CT7-2E1 ALERT SERVICE BULLETIN - 72- A0033 R00

SB 72-A0033 R00 ENGINE - ACCESSORY SECTION MODULE (72-60-00) - REMOVAL OF PARTICLE SEPARATOR BLOWER P/N 6034T62P18 AND ACCOMPANYING V-BAND COUPLING ASSEMBLY P/N 4042T36P02 OR P/N 5056T10P01

Issued:
01/18
/2024

Particle Separator Blower and V-Band Coupling Assembly - Removal and Installation
Figure 1

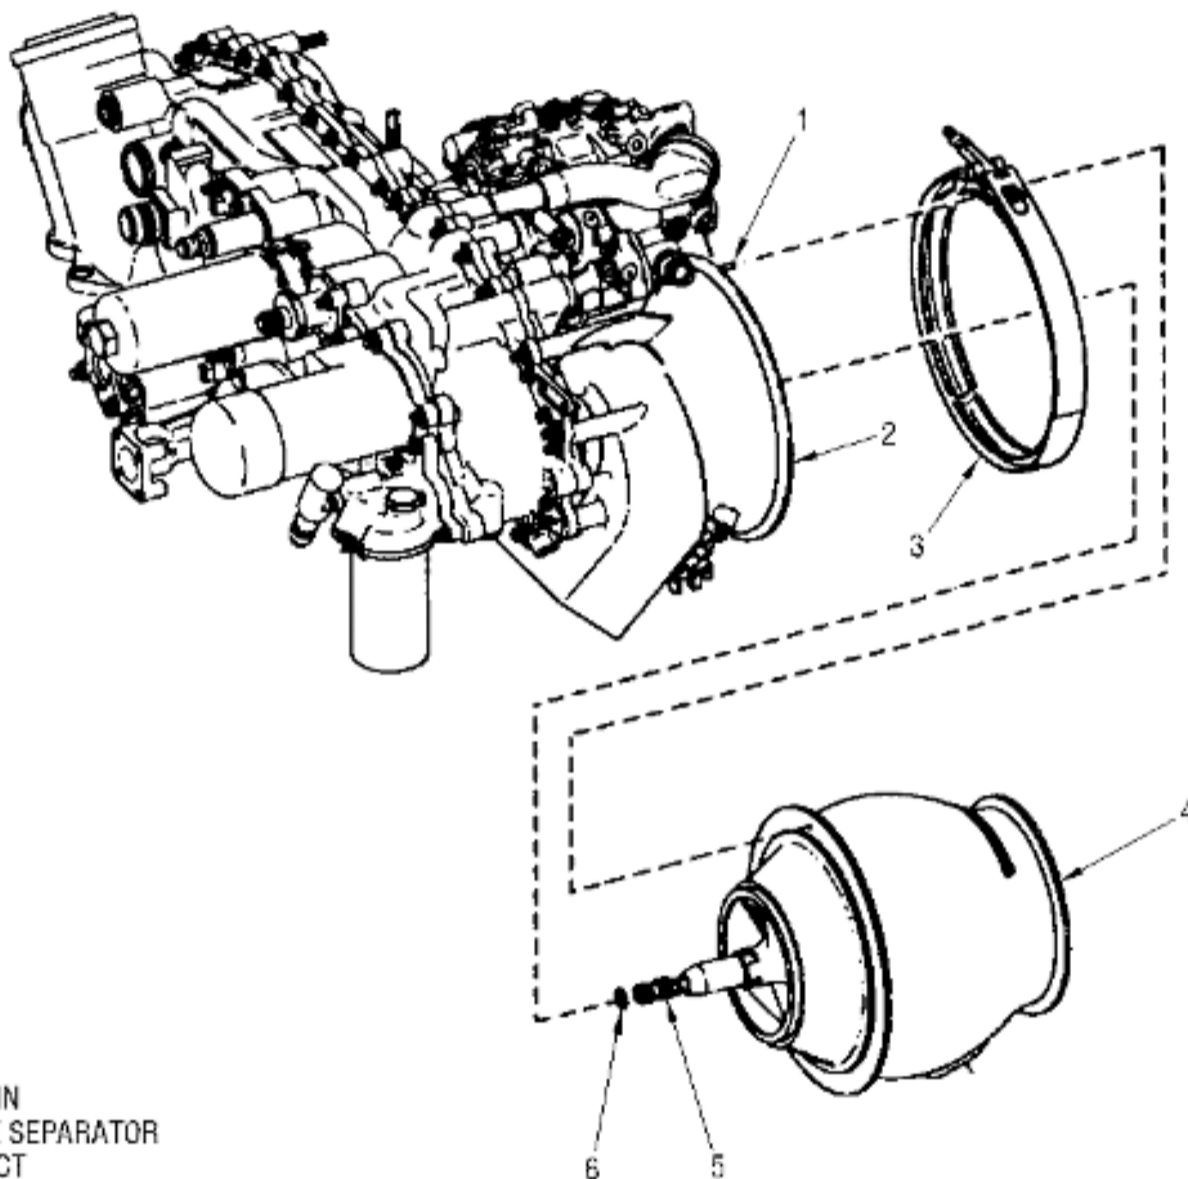
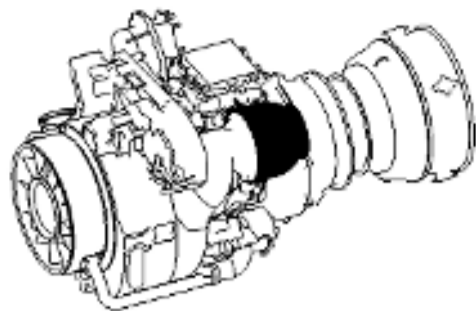
Remove the old particle separator blower P/N [6034T62P18](#) (4, [figure 1](#)) and V-band coupling assembly P/N [4042T36P02](#) or P/N [5056T10P01](#) (3) prior to accruing 3,000 cycles since new. Refer to CT7-2E1 MM GEK 112043-02, 72-60-00, REMOVAL AND INSTALLATION, TASK 72-60-00-400-801, applicable paragraphs.

Install the new particle separator blower P/N [6034T62P19](#) and V-band coupling assembly P/N [4135T12P02](#). Refer to CT7-2E1 MM GEK 112043-02, 72-60-00, REMOVAL AND INSTALLATION, TASK 72-60-00-400-801, applicable paragraphs.
